Work Order ID 133746

DART SERVICE INSTRUCTION

TO AMEND INSTALLATION INSTRUCTIONS IIN-D407-781-2 REV. A OR LATER APPROVED REVISION
AND INSTRUCTIONS FOR CONTINUED AIRWORTHINESS ICA-D407-781 REV. 3 OR LATER REVISION

REF. TCCA STC: SH08-60
REF. FAA STC: SR002726NY
REF. EASA.IM.R.S.01541

**FIGURE 1 - D3879-1 BAGGAGE COMPARTMENT WALL
PROTECTOR - ALTERNATE INSTALLATION**

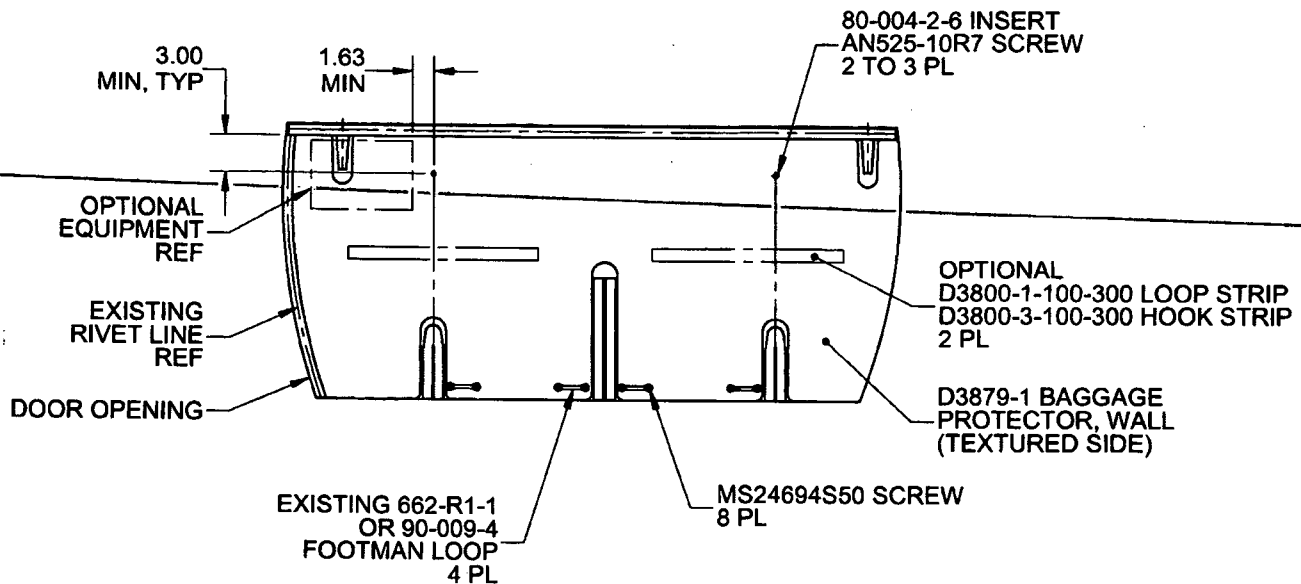
In some aircraft, the top portion of the D206-781-041 Baggage Compartment Wall Protector Kit cannot be installed as indicated in IIN-D407-781-2. The purpose of this DSI is to provide an alternate mounting method to fasten the top portion of the D206-781-041 Baggage Compartment Wall Protector Kit.

It is acceptable to replace qty(2) D3930-1 Clips with qty(2) 80-004-2-6 Inserts. Locate and mark location of the two attachment holes on the baggage compartment wall as shown in Figure 1 of this service instruction. Install 80-004-2-6 Inserts at the marked locations in accordance with Section 3-2-12 of BHT-206-SRM-1. It is acceptable to trim the wall protectors to accommodate optional equipment or transfer attachment holes to the wall protector and install the optional equipment on top of the wall protector with longer fasteners.

Amend the D206-781-041 Baggage Compartment Wall Protector Kit parts list as follows:

Qty -061	Qty -031	Qty -041	Part Number	Description
X			D206-781-061	BAGGAGE COMPARTMENT PROTECTOR KIT (FLOOR AND WALL)
1	X		D206-781-031	BAGGAGE COMPARTMENT FLOOR PROTECTOR KIT
1		X	D206-781-041	BAGGAGE COMPARTMENT WALL PROTECTOR KIT
		2	AN525-10R7	SCREW
		2	80-004-2-6	INSERT
